N1078A-04

# Information Only Service Note

## N1078A 64 GBd Single-Mode Optical/Electrical Clock Recovery

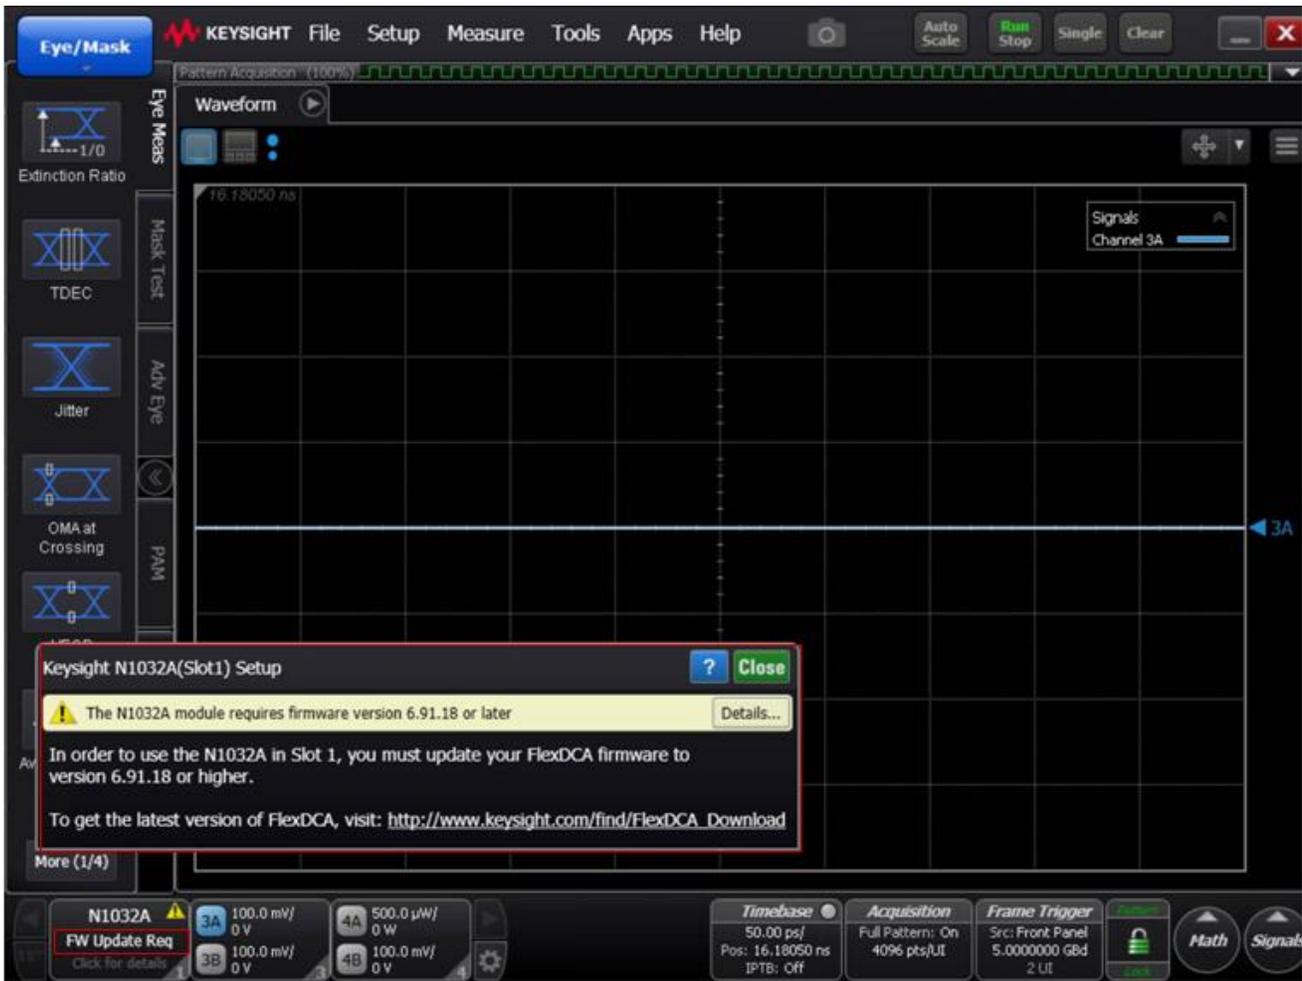
With the instrument connected to FlexDCA, if a message like the one below is displayed, FlexDCA must be updated to the indicated version (or later):

To update FlexDCA software, download from [www.keysight.com/find/flexdca\\_download](http://www.keysight.com/find/flexdca_download) and install. While only the indicated version is required, updating to the latest version is recommended.
